Independent Pricing and Regulatory Tribunal
New South Wales

**Assessment of
Contributions Plan No. 15 (2020)
– Box Hill Precinct**

The Hills Shire Council

**Final Report
Local Government**

Figure 4.2 Site area for the Withers Road/Barry Road & Hezlett Road and Barry Road bypass roads

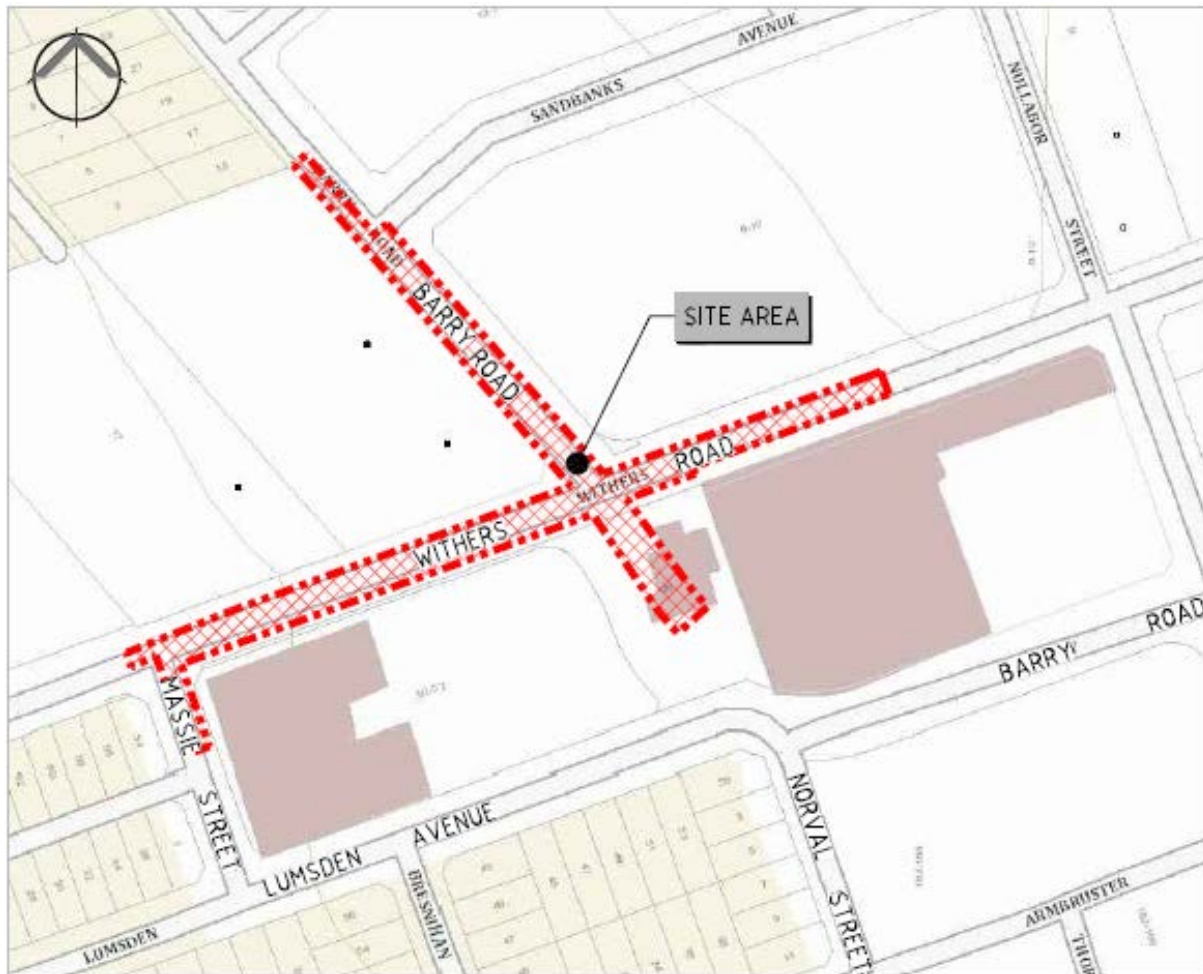
The Diversi Consulting designs cover works that extend beyond the signalised intersection and include re-alignment and widening the future sub-arterial, Withers Road, and future collector road, Barry Road in North Kellyville (Figure 4.2).

▽ Site: BHT18 [AM_Terry Road_High Street]

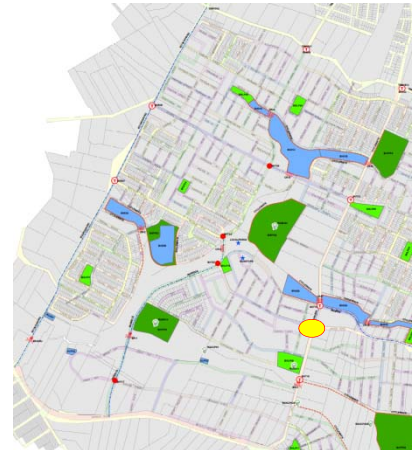
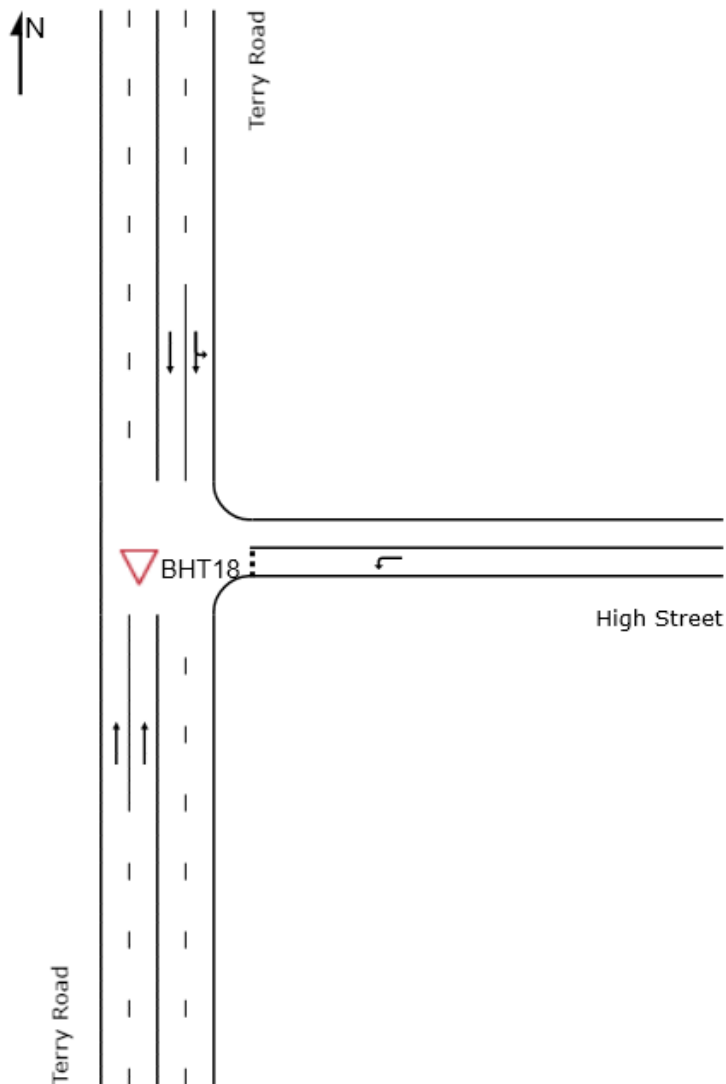
- 1 Remove the cost of the signalised T-junction intersection at the corner of Terry Road and High Street [BHT18] because nexus is established for a pedestrian crossing only. This would reduce costs in the plan by \$5,502,778. 21

- 1 Remove the cost of the signalised T-junction intersection at the corner of Terry Road and High Street [BHT18] because nexus is established for a pedestrian crossing only. This would reduce costs in the plan by \$5,502,778.
- 2 Increase the cost of the intersection at the corner of Prosper Street and Mount Carmel Drive [BHT17] by \$346,740 because nexus is established for a signalised intersection instead of a roundabout.
